# 1101 WESTERN AVE

Early Design Guidance #2  
SDCI # 3033606-EG  
July 9, 2019

SUMMARY OF BOARD COMMENTS: EDG #1

VOLUMETRIC SECTIONS - OPTION 1

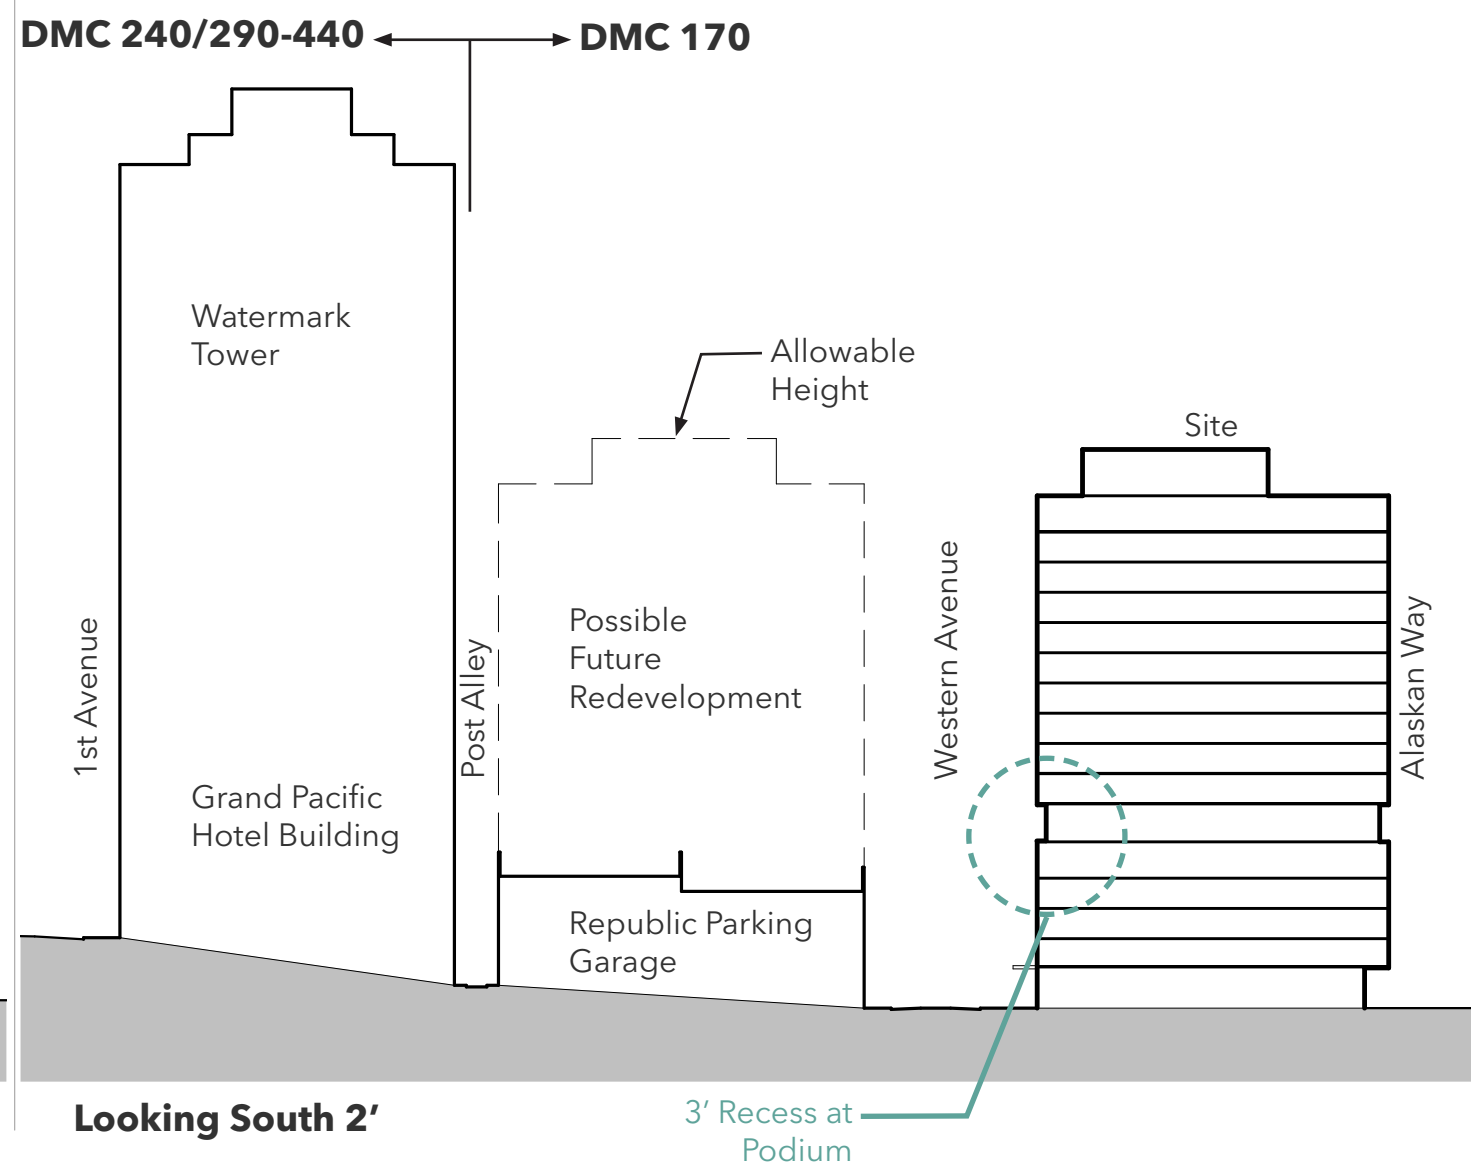
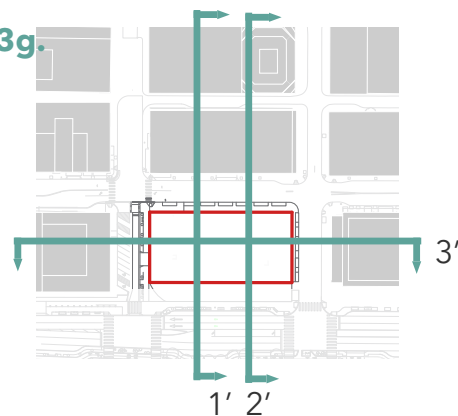
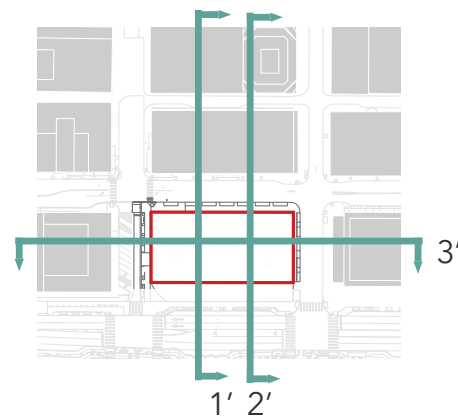
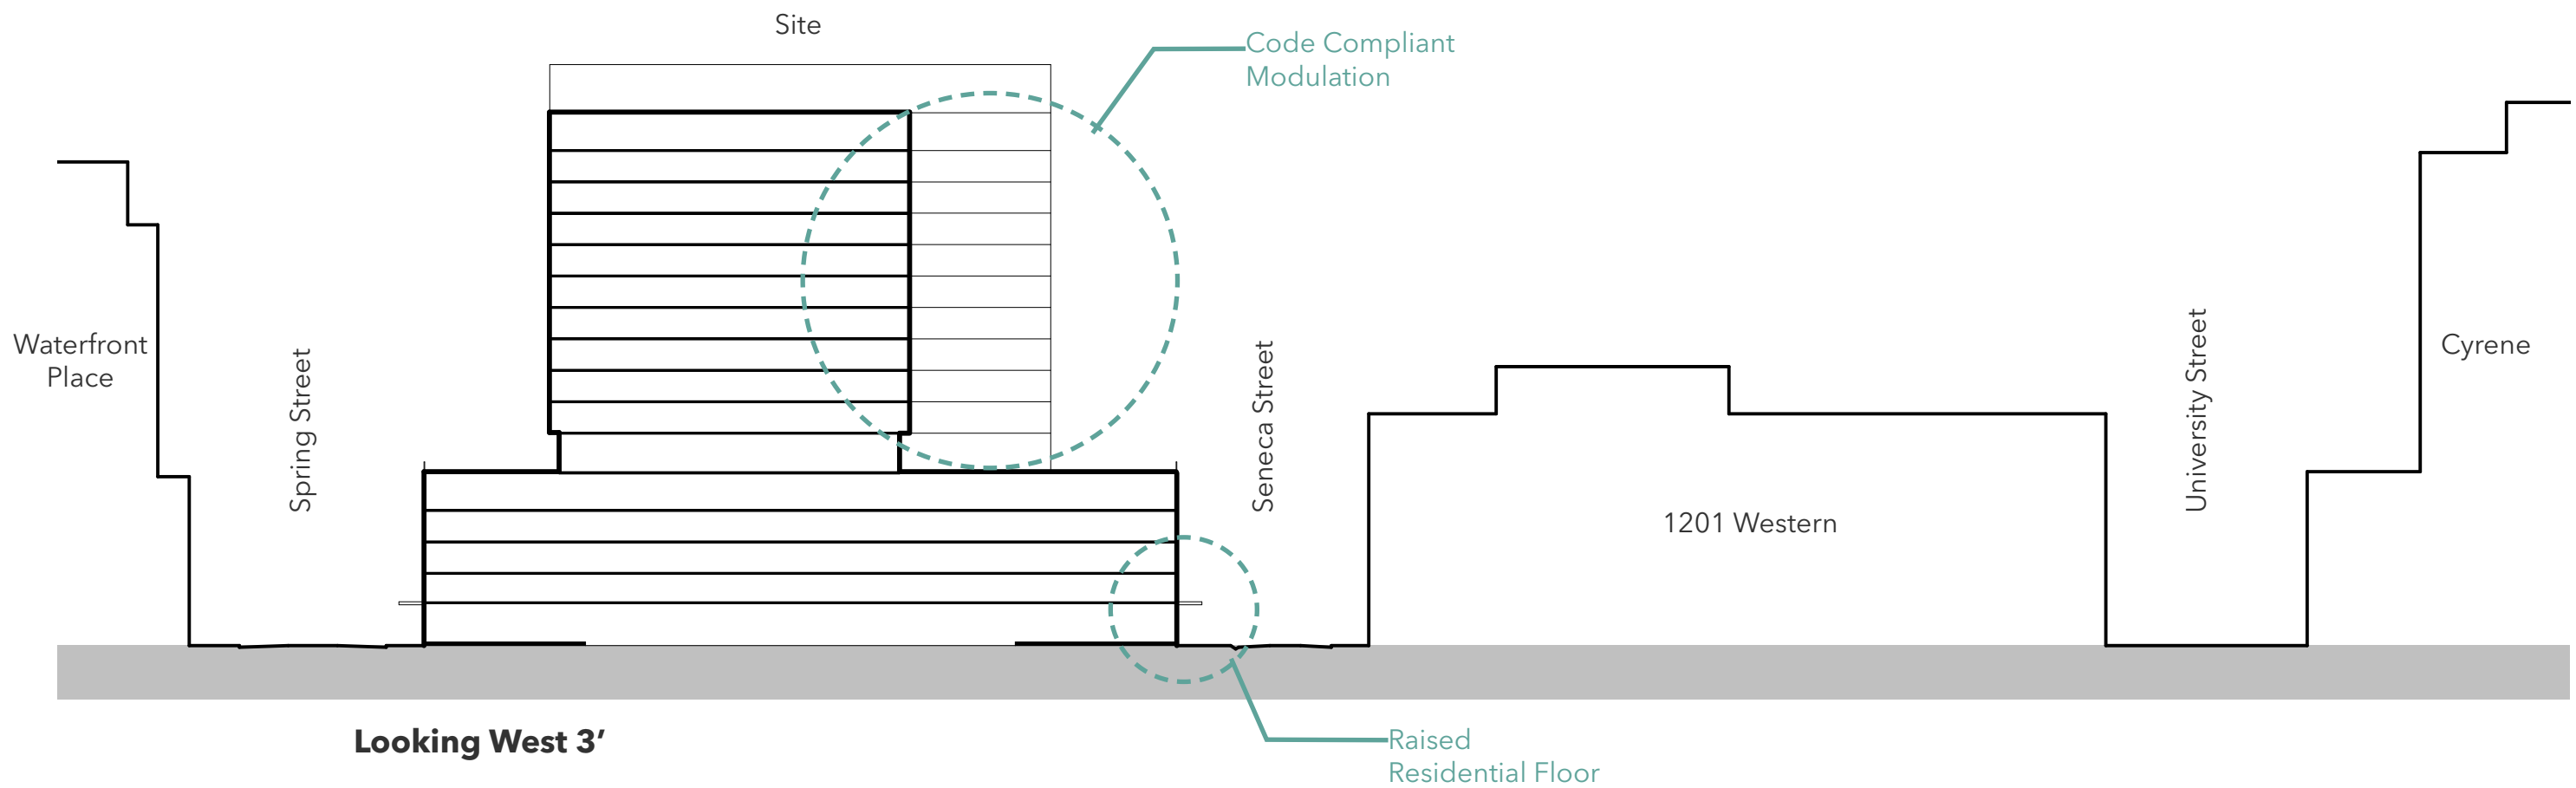
**The Board requested that the design team provide sections through the massing options to show the volumetric massing of each.**

Option 1 sections demonstrate the setback at level 6 to differentiate base from tower. Roof top volume that is pulled east is consistent with massing of neighborhood buildings stepping down to the waterfront. At ground level weather protection and overhang at Alaskan Way façade enhances the pedestrian experience. Modulation on Western pulls back to provide more space to the shorter building across Seneca.

Ground Level Plan

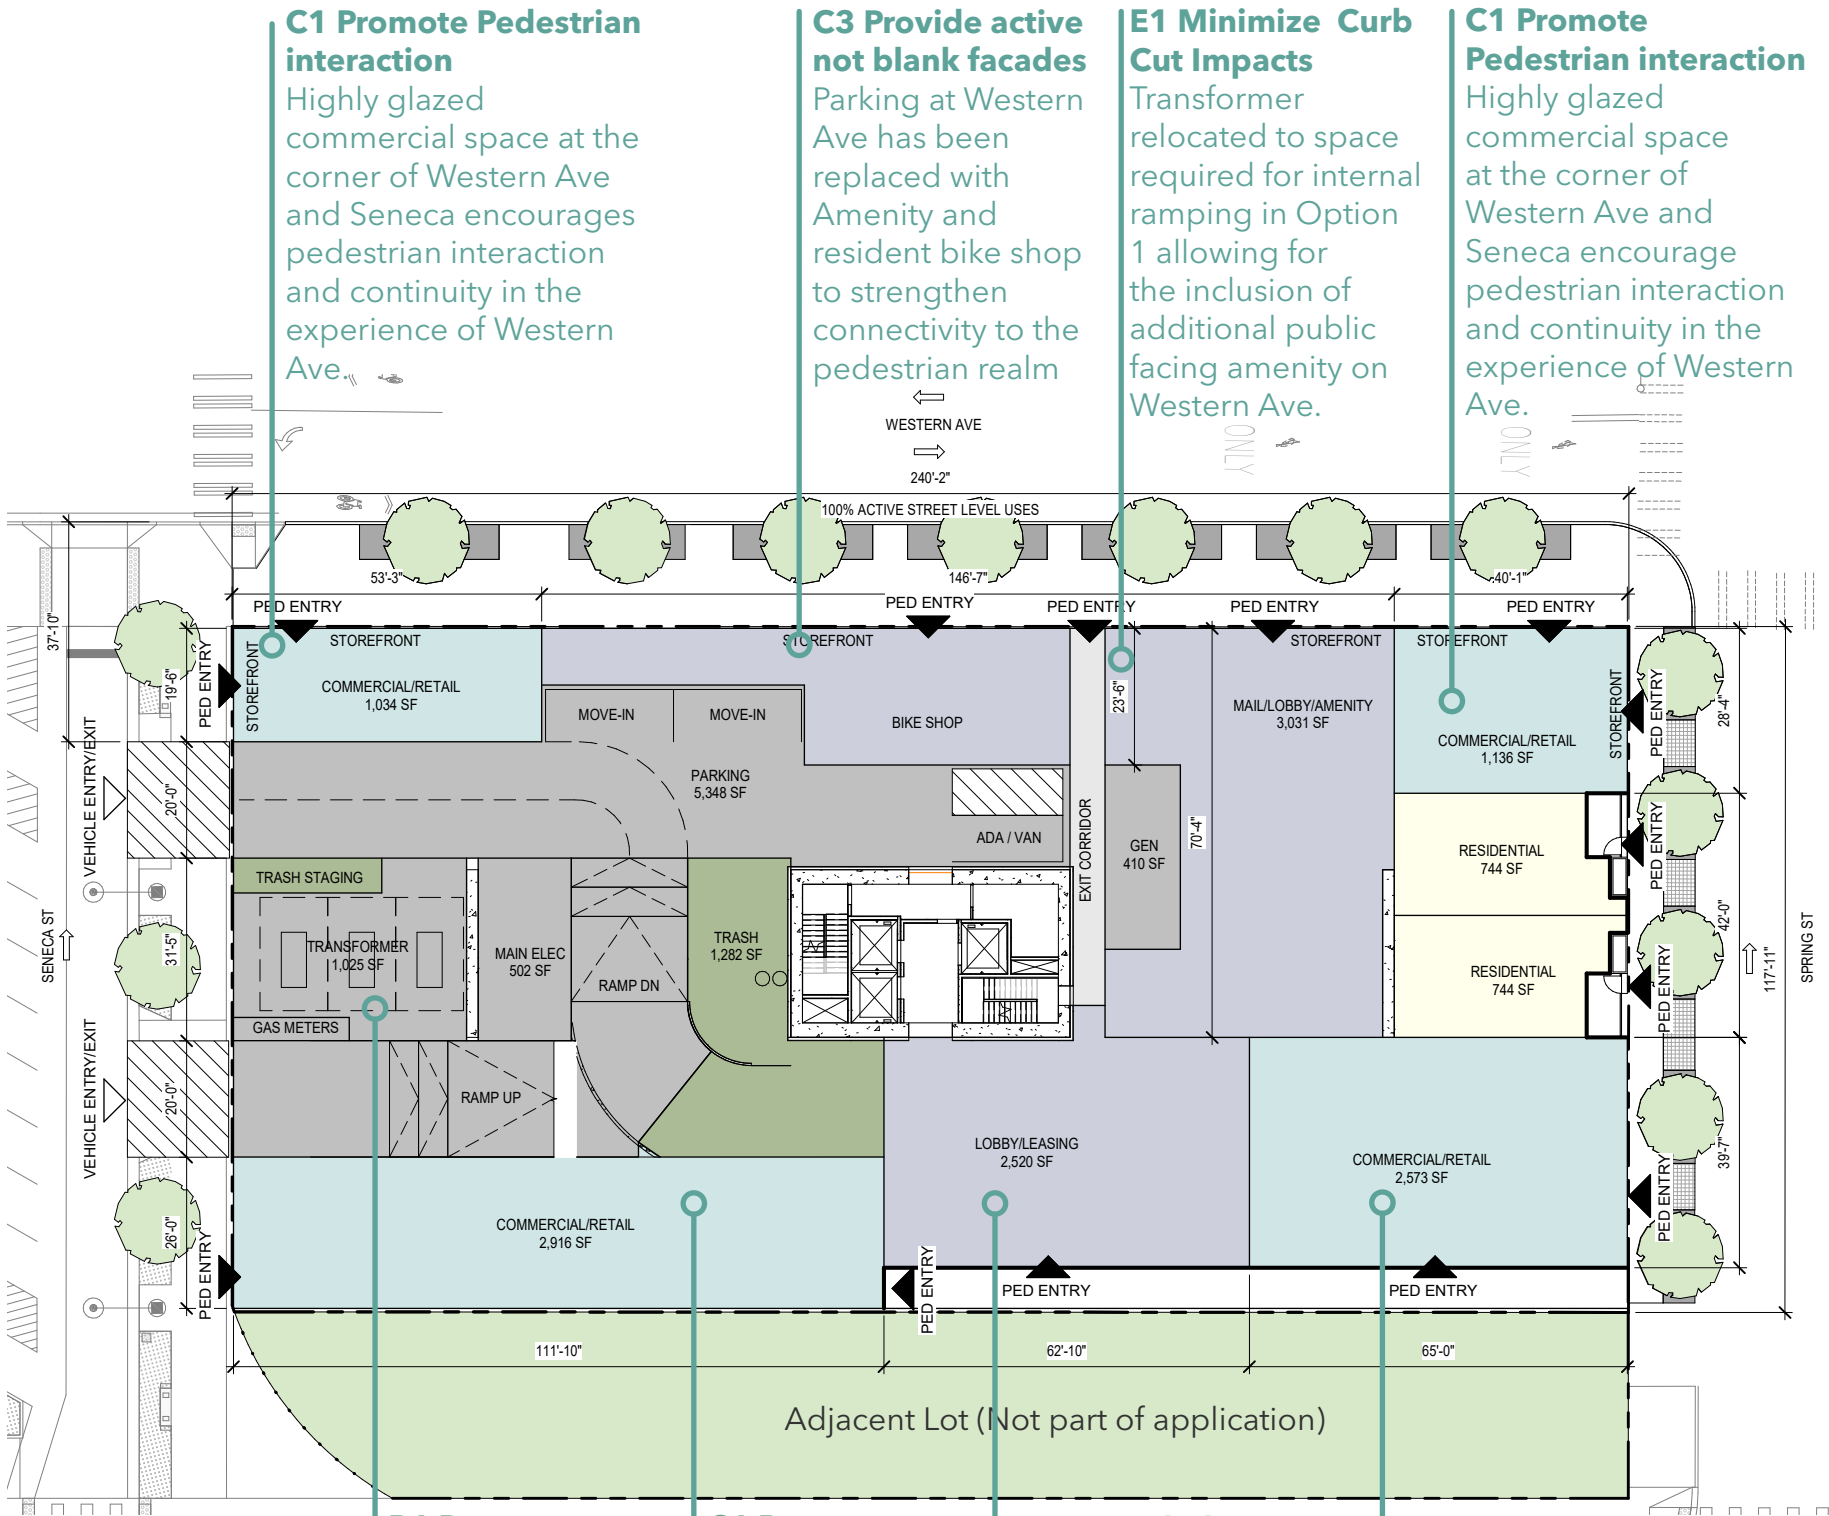
At EDG #1 The Board commented that, similar to the massing options, the ground levels of the three options were too similar. They also noted that the proposed residential, solid waste staging, parking, and service room uses on Western Ave were not supportive of the neighborhood context and a pedestrian environment. Option 2 locates driveway access curb cuts, trash staging and the transformer on Seneca and eliminated parking abutting Western Ave. allowing the frontage at Western to be totally characterized by commercial, active lobby and amenity programming.

**B1 Response to Neighborhood Context** Additional curb cut allows for the inclusion of all service related functions on Seneca per the Board's request.

**C3 Provide active not blank facades**  
Parking at Western Ave has been replaced with Amenity and resident bike shop to strengthen connectivity to the pedestrian realm

View of South East Corner from Western Avenue

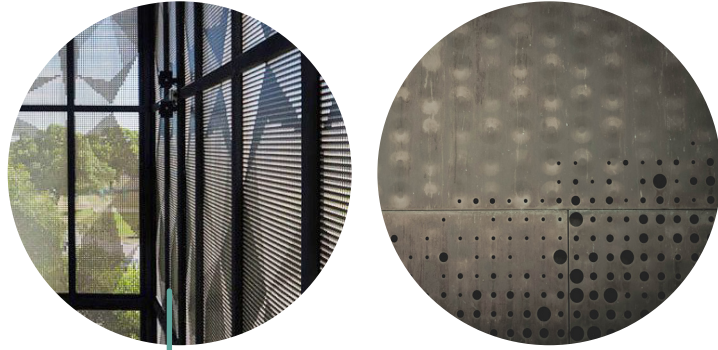
The Board was concerned about the multiple levels of parking along Western Ave at the floors above the street level as this use will not help to activate the street. The Board requested that the design team provide a design at the floors above the street level that reinforces the features found in the neighboring buildings. The design team explored alternative design solutions for above grade parking. Because of the high water table and porosity of fill soils only one level of below grade parking is proposed. The design team was able to accommodate all additional above grade parking at a single level, Level 2. Option 2 conceals this parking by integrating it into the expression of the ground level storefront, placing an emphasis on the lightness and transparency of functions associated with the public realm and achieves the Board's goal of minimizing above grade parking at Western Avenue.

Panels that mimic the rhythm and frame of the glazing system below are infilled with mesh or perforated panel to help to volumetrically distinguish changes in massing and materiality.
